MTF FOMILD

Comments #142, 48, 88, 218

Chris DiMinico
MC Communications/PHY-SI LLC/Panduit
cdiminico@ieee.org

slide 11 of
 kocsis_3ck_adhoc_01_011321.pdf)

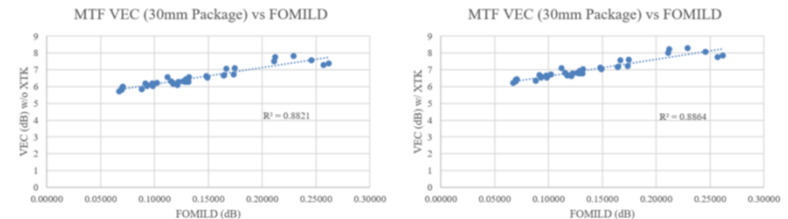
CI 162B SC 162B.1.3.1 P 269 L 36 # 218
 Haser, Alex Molex
 Comment Type T Comment Status D MTF FOMILD
 FOM_ILD limit is too strict for measured data
 SuggestedRemedy
 Relax FOM_ILD to 0.18 dB (see slide 11 of kocsis_3ck_adhoc_01_011321.pdf) →
 Proposed Response Response Status W
 PROPOSED ACCEPT IN PRINCIPLE.
 Resolve using the response to comment #142.

- Adding maximum crosstalk to the MTF results in ~ +0.5dB VEC
- VEC and FOMILD are well correlated and VEC<7.5dB results in and FOMILD<0.187dB
- Recommend setting the MTF FOMILD requirement to 0.18dB for D1p5 release
 - Can be adjusted in future drafts if VEC requirements change or more MTF data becomes available
